RE: 2103 Los Luceros Rd NW Grading & Drainage Plan

Hydrology File: H12D025 Case # HYDR-2025-00324

Based upon the information provided in your submittal received 09/08/2025, the Grading & Drainage Plan **is not** approved for Building Permit. The following comments need to be addressed for approval of the above referenced project:

GRADING AND DRAINAGE PLAN 2103 LOS LUCEROS ROAD NW ADRIAN OGLESBY

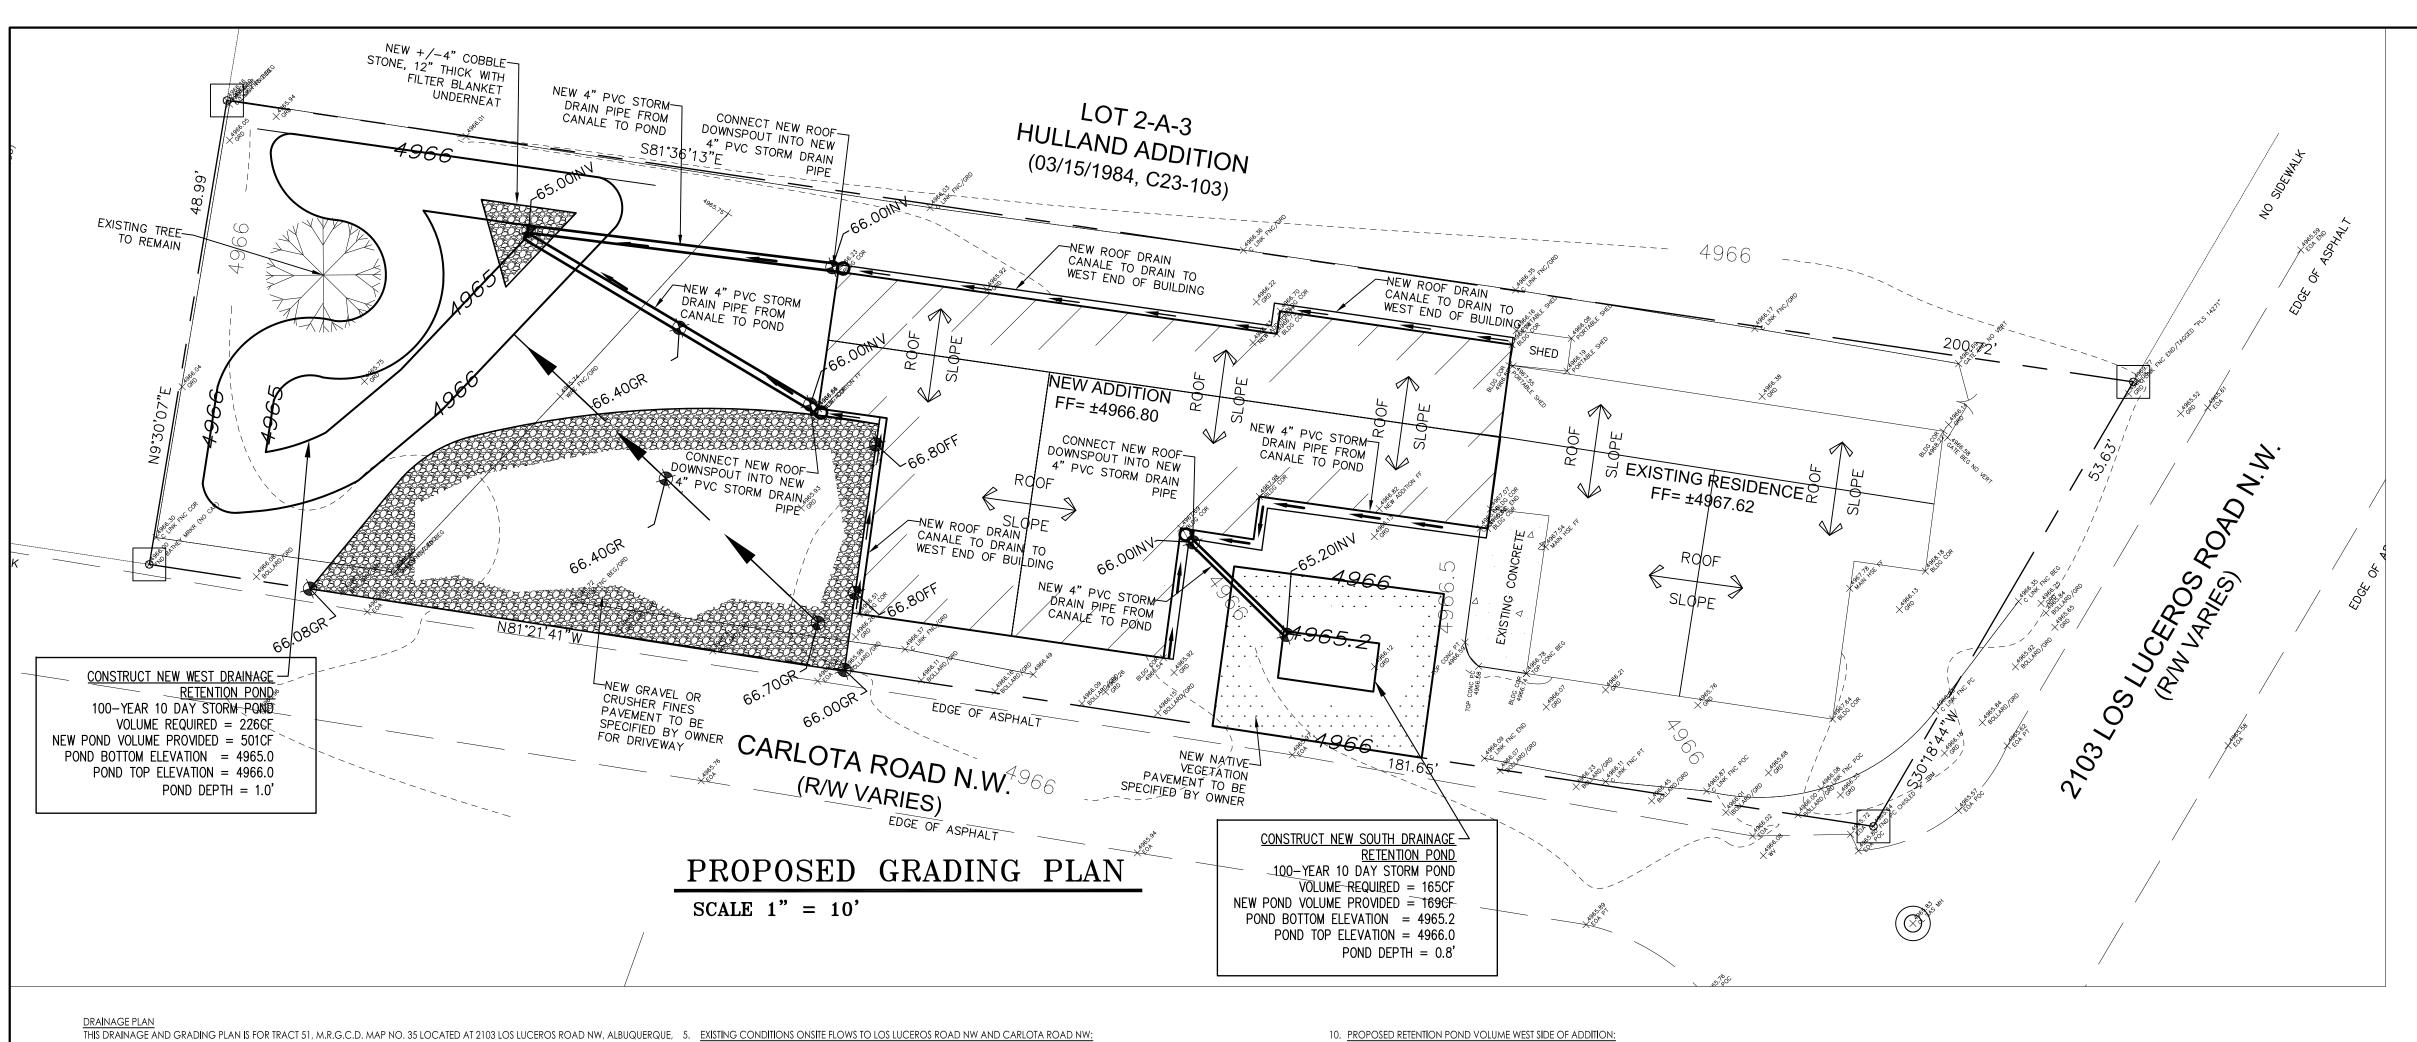
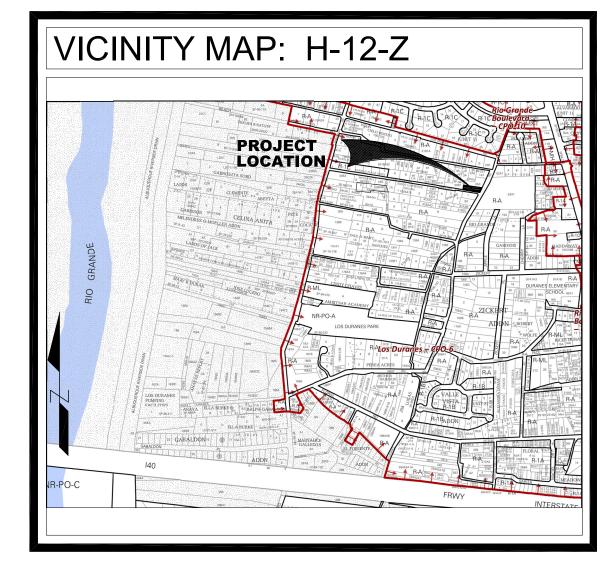
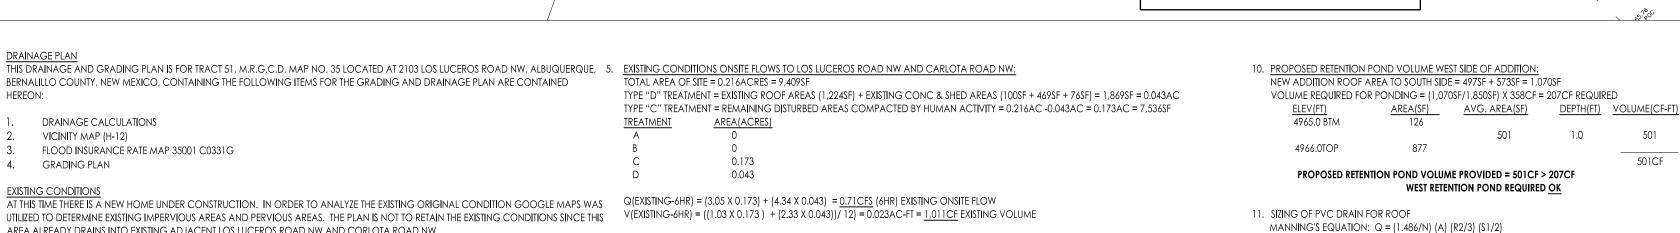
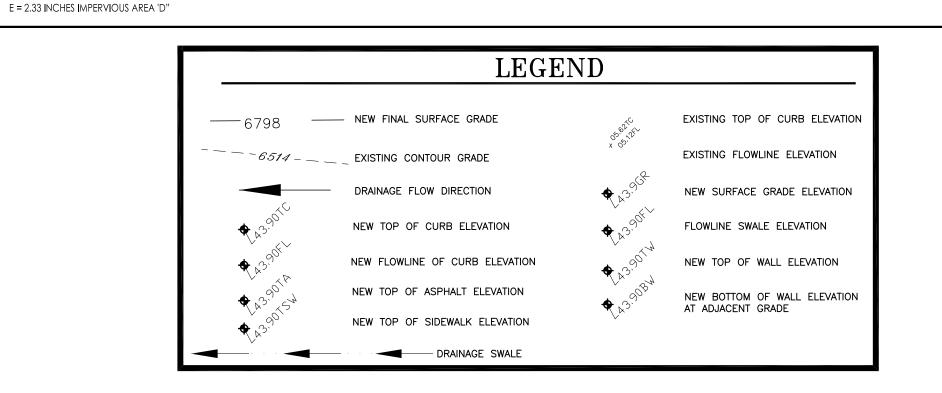
- 1. Per the 6-5-5-3 of the Sidewalk Ordinance, the property owner of the property is responsible for building the curb & gutter, and sidewalk along Los Luceros and Carlota. The project will have to go to the Development Facilitation Team (DFT) for approval of the Infrastructure List unless a variance is granted. Please show the curb & gutter, and sidewalk on the plans.
- 2. Please provide the Benchmark information (location, description and elevation) for the survey contour information provided.
- 3. Since this site is in the Valley region, please follow Article 6-5 Valley Drainage Criteria of the DPM. The following conditions must be applied to the site:
 - A permanent perimeter wall or barrier around the development is required to contain the 100 year 24 hour storm developed runoff
